QUALITY ASSURANCE DEPARTMENT
NONCONFORMANCE REPORT (NCR)

PROJECT CPSES _____ JOB NO 35-1195 PAGE 1 OF 2

BROWN & ROOT, INC.
Quality Assurance Department
Nonconformance Report (NCR)
CPSES-35-1195

NCR NO. M-2507 R. 2

SERIAL NO. N° 34851 REV. 3

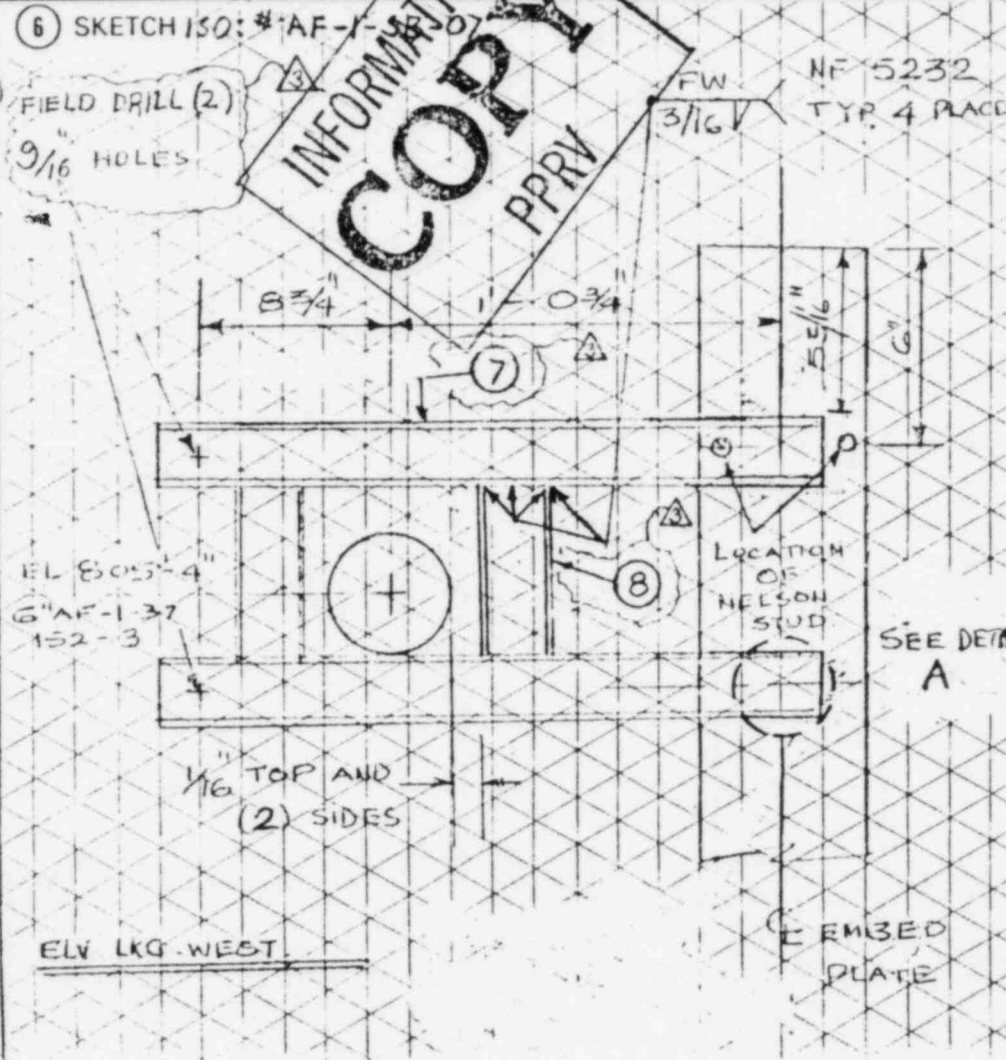
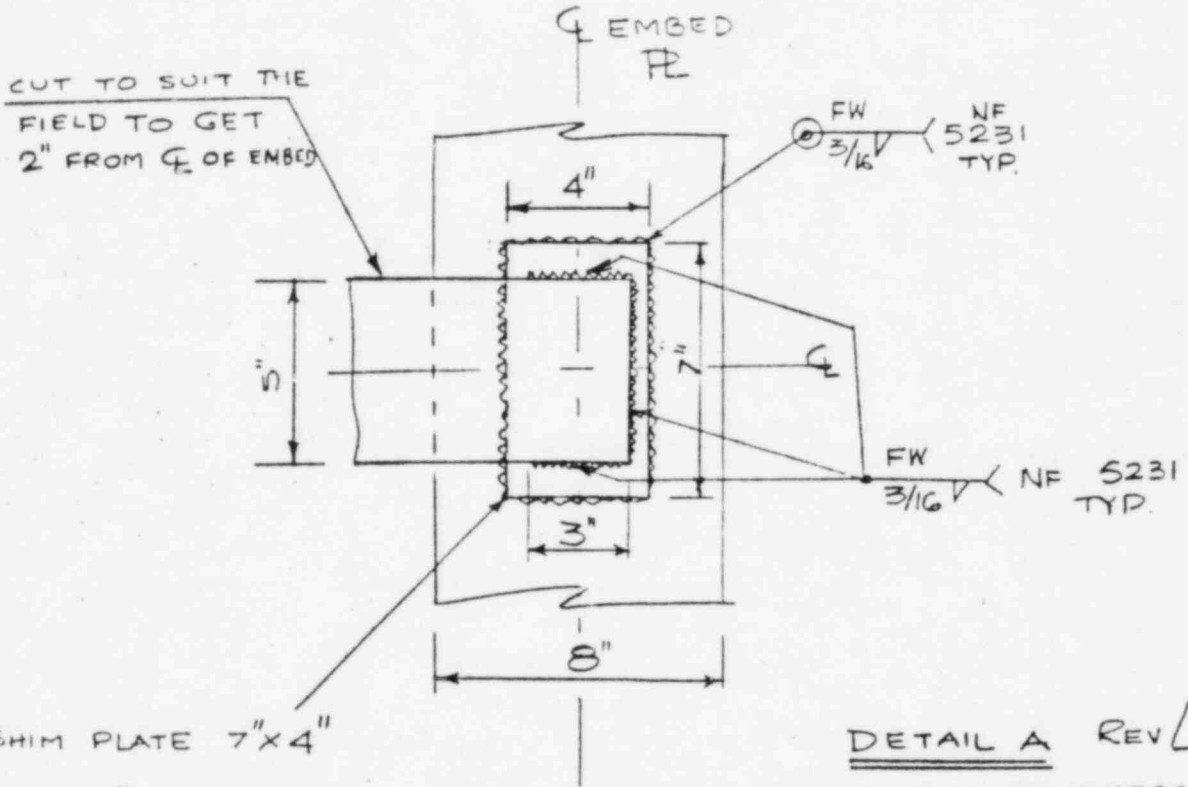
4) REASON FOR CHANGE: TO UTILIZE EMBED PLATE HCR# M-2374
 TO INSTALL SHIM (DETAIL A)
 CHANGE WELD ITEM #2 TO ITEM #4

- REMOVE WELD # 1
- THRU # 4
- DELETE ITEM # 1
- DELETE - QUANTITY - 2
- ITEM # 3
- DELETE ITEM # 2, QUAN. 2

- ADD ITEM # (7) CS X 6'7 SA-36 2'-2 1/2" LONG QUANTITY - 2
- CS R 3/8" X 4" X 7" SA-36, DETAIL A
- CS R 1/4" X 4" X 7" SA-36, DETAIL A

- ⑤ USE $\frac{3}{8}$ " THICK PLATE AT TOP
- ⑥ USE $\frac{1}{4}$ " THICK PLATE AT BOTTOM

TYP. EXCEPT THICKNESS OF THE SHIM PLATE AS PER ITEM # ⑤ AND ⑥

To Don Sutton
REF. AEI-035-029-S33A
DATE 10-19-80

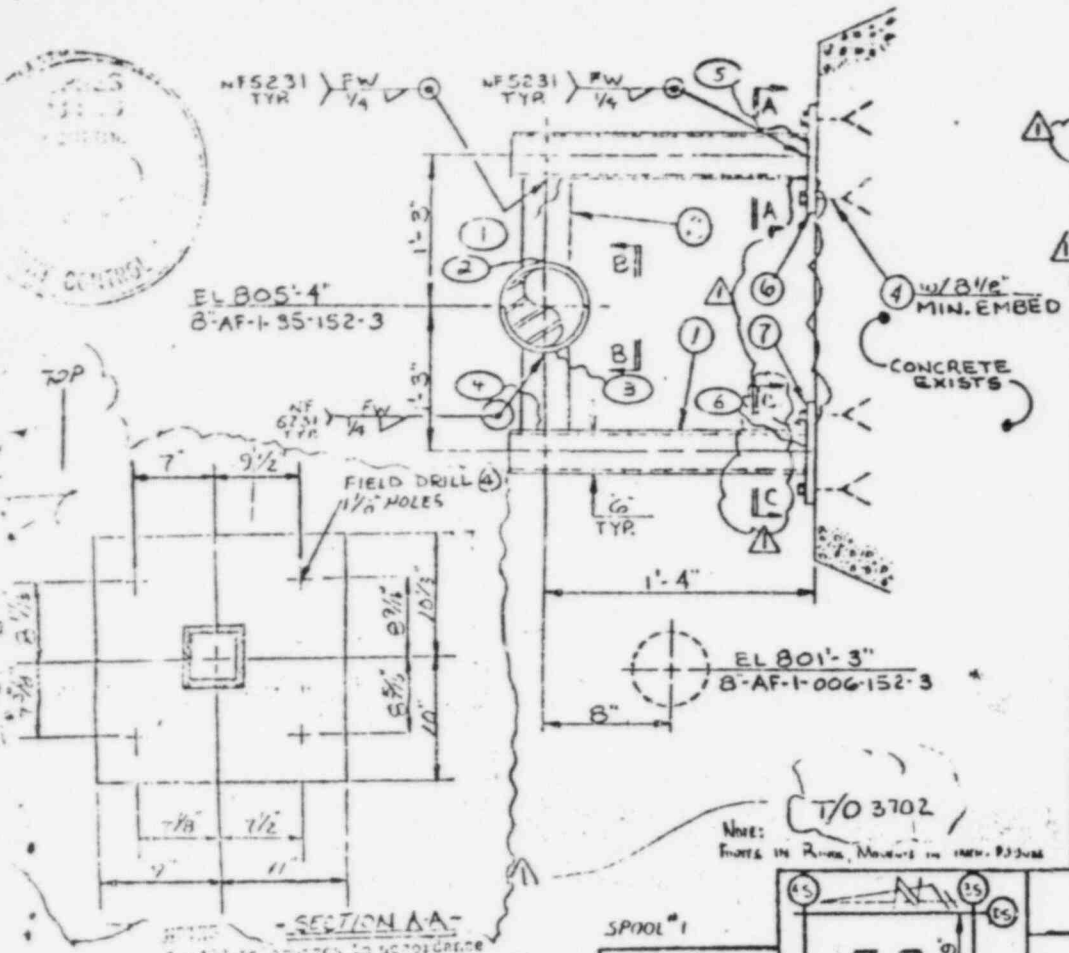
THE REFERENCED HANGER
HAS 1 ANCHOR HOLE HITTING REBAR
AT 5 1/2" DEEP ON THE TOP
PLATE (BOTTOM RIGHT CORNER)
THE ORIENTATION SEEMS TO BE AT
A 45° ANGLE TO THE VERTICAL. PLEASE
CHECK THIS OUT FOR REBAR CUTTING
DUE TO THE IMPORTANCE OF THIS
ANCHOR

DATE 10/23/80
No structural repair
should be encountered
at these locations
and depths. The loss
encountered in probably
a construction "stiff"
"template" base and
as such may be
cut as requested.
